To: Acme Township Board of Trustees and Planning Commission
From: Sharon E. Vreeland, Township Manager
Date: 03/23/11
Re: VGT-Phase I SUP #2009-1P Status Update

I wanted to take this opportunity to respond to your questions outlined in a March 3, 2011 e-mail to Ms. Sharon Vreeland regarding our January 17, 2011 Planning Analysis for the Phase I Village at Grand Traverse.

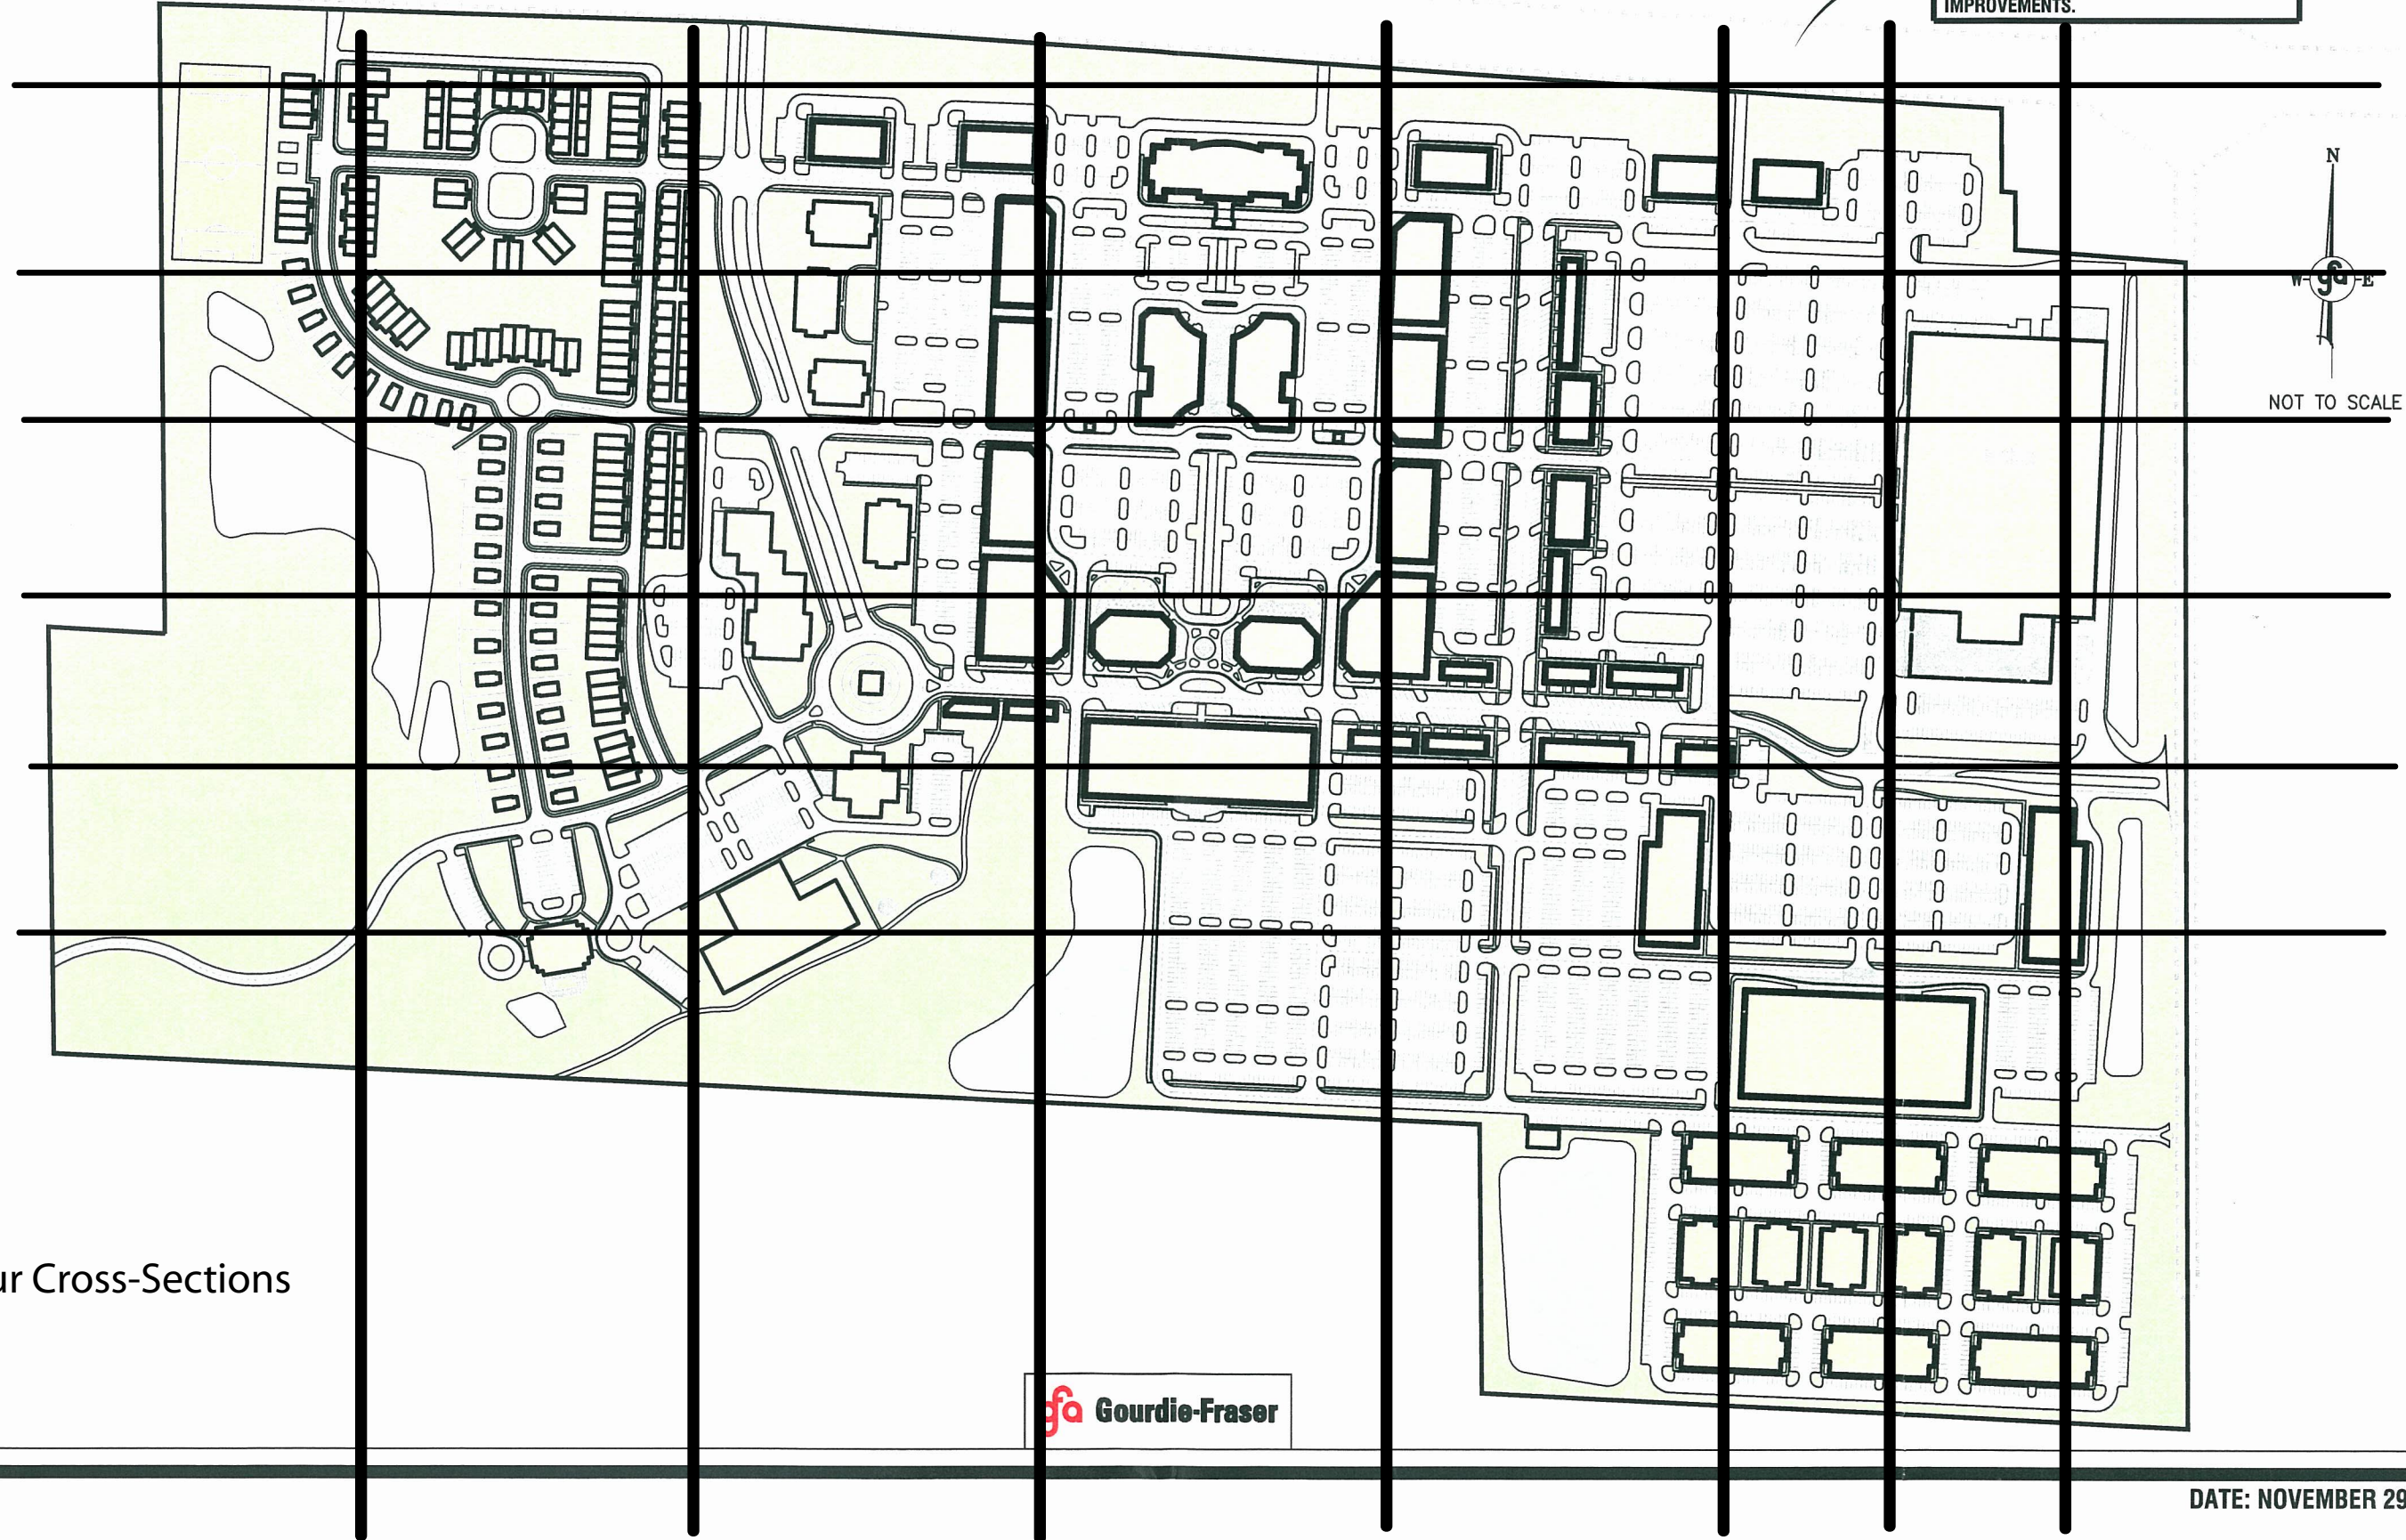
3. Contour Elevations. Due to the topography of the site and the location of residential and non-residential land uses a cross-section of the site would be beneficial to understand elevation changes and their relationship to setbacks, landscaping, lighting, and drainage. I have attached a drawing to illustrate the intent of our comments.

4. Contour Elevations. Due to the topography of the site and the location of residential and non-residential land uses a cross-section of the site would be beneficial to understand elevation changes and their relationship to setbacks, landscaping, lighting, and drainage. I have attached a drawing to illustrate the intent of our comments.

The Village At Grand Traverse - Overall Conceptual Plan

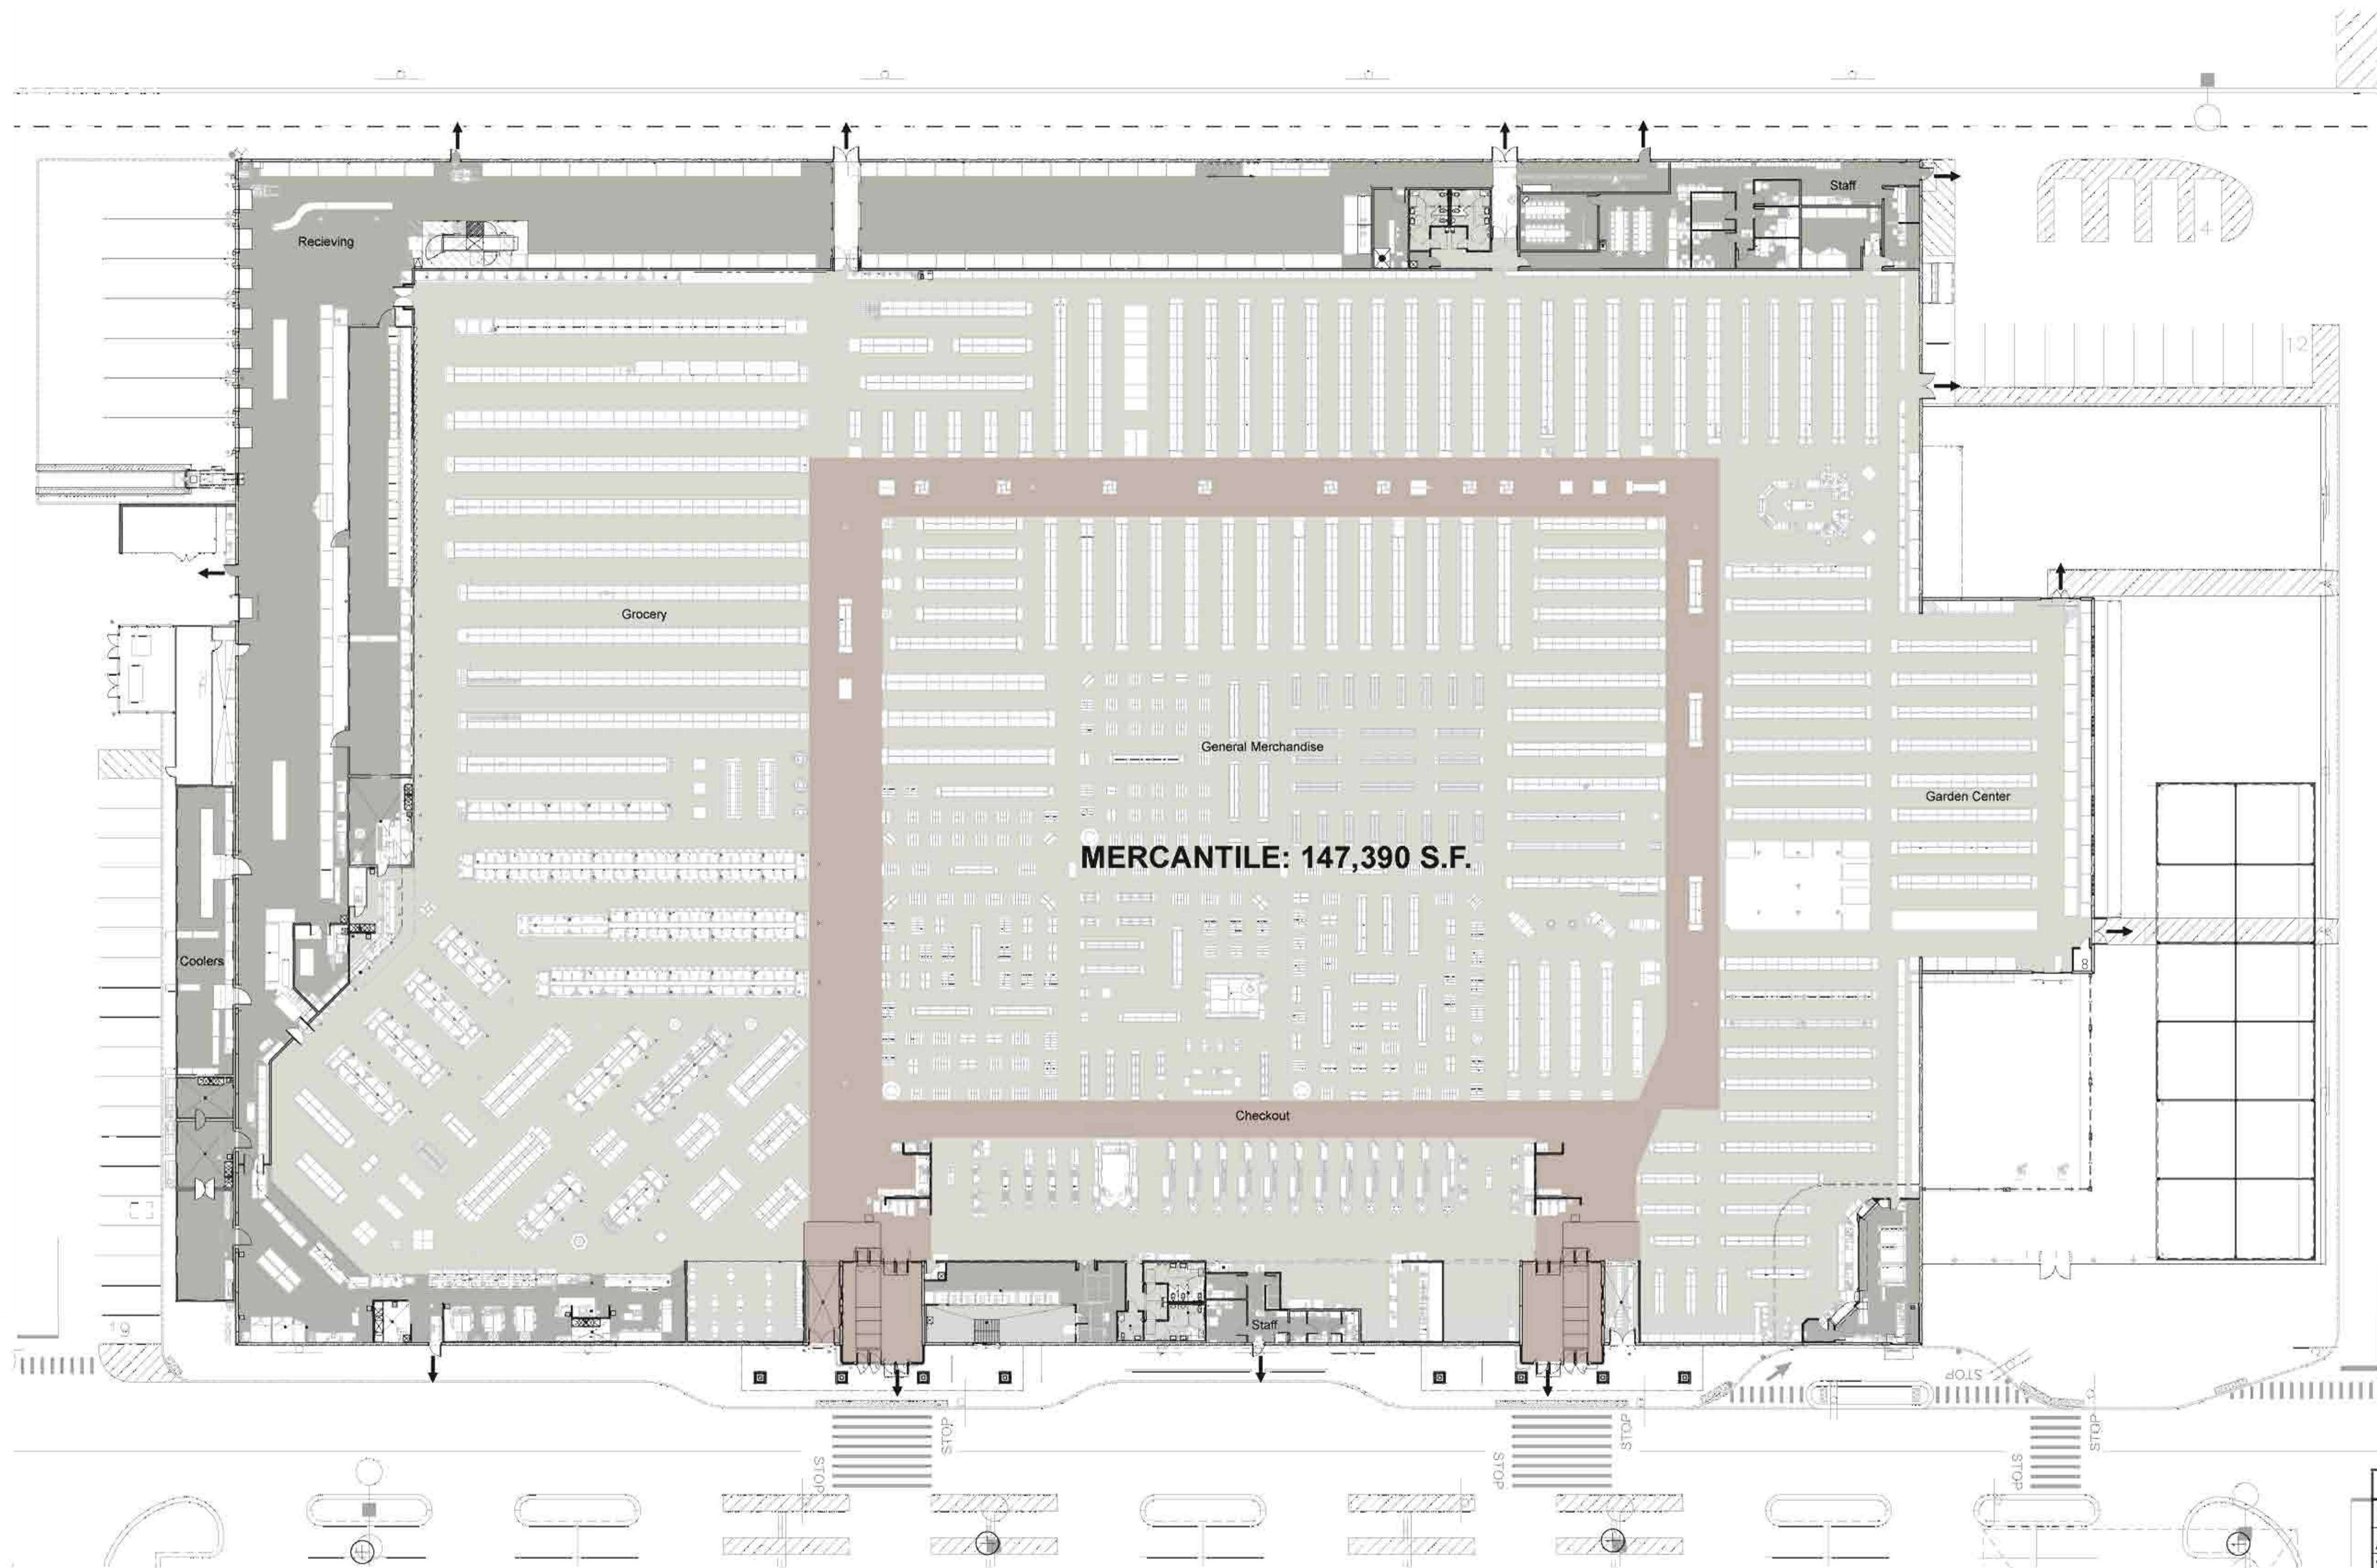
5. Roundabout. During one of the several traffic-related meetings between the review agencies and your consultants, Mr. Steve Dearing, P.E., PTOE, mentioned that the internal roundabout was an earlier version of roundabout geometry which has subsequently been revised and no longer used. For example, the conceptual plan roundabout shows a small building with sidewalks which is strongly discouraged in new roundabout design guidelines.
